Application for Licence Amendment

Licence Number	L6297/1993/11
Licence Holder	CLEANAWAY CO PTY LTD
ACN	127 853 561
File Number	2012/001161-1
Premises	Cleanaway Co Pty Ltd (Kwinana) Mason Road KWINANA BEACH WA 6167 Lot 15 on Diagram 87731
Date of Report	21/09/2022
Decision	Revised licence granted

On 22 February 2022, the Licence Holder submitted an application to the department to amend Licence L6297/1993/11 under section 59 and 59B of the *Environmental Protection Act 1986* (EP Act). This amendment seeks to revise the Storage and Processing Areas figure of the licence to reflect the optimal use of the Premises following 5 months operation of the new dangerous goods store.

Figure 2. Proposed Storage and Processing Areas

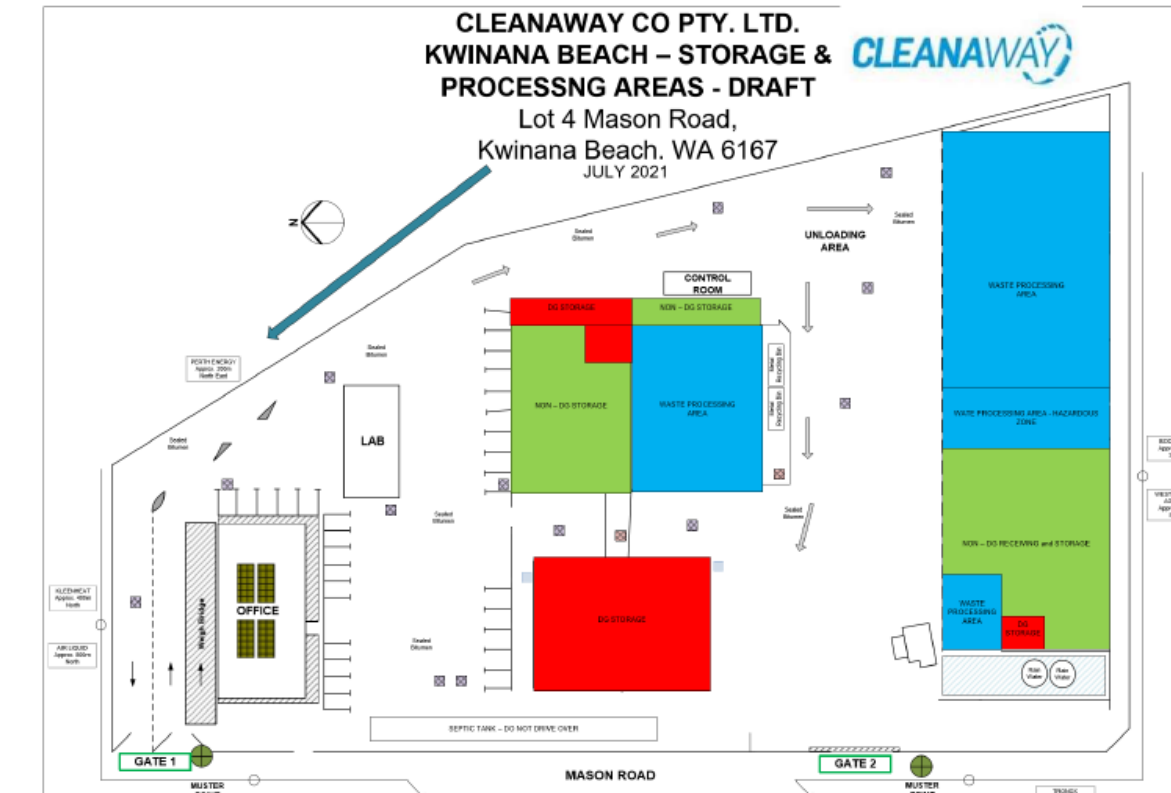
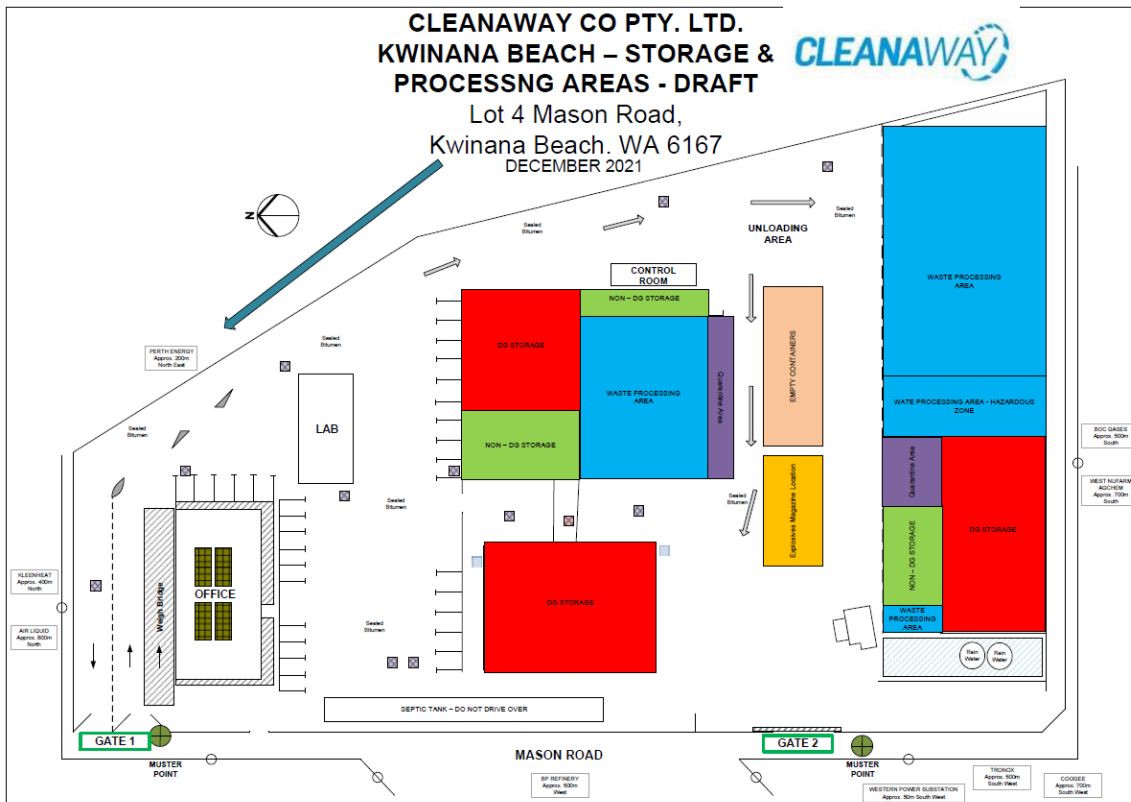
No changes to activities other than updating the dangerous goods storage locations is proposed. Figure 1 shows the current Storage and Processing Areas, while Figure 2 shows the proposed Storage and Processing Areas.

Condition 29	Groundwater monitoring report requirements included.
Schedule 1, Figure 3	Figure 3: Storage and processing area plan has been updated.
Schedule 1, Figure 5	Inclusion of Figure 5: Groundwater monitoring well locations
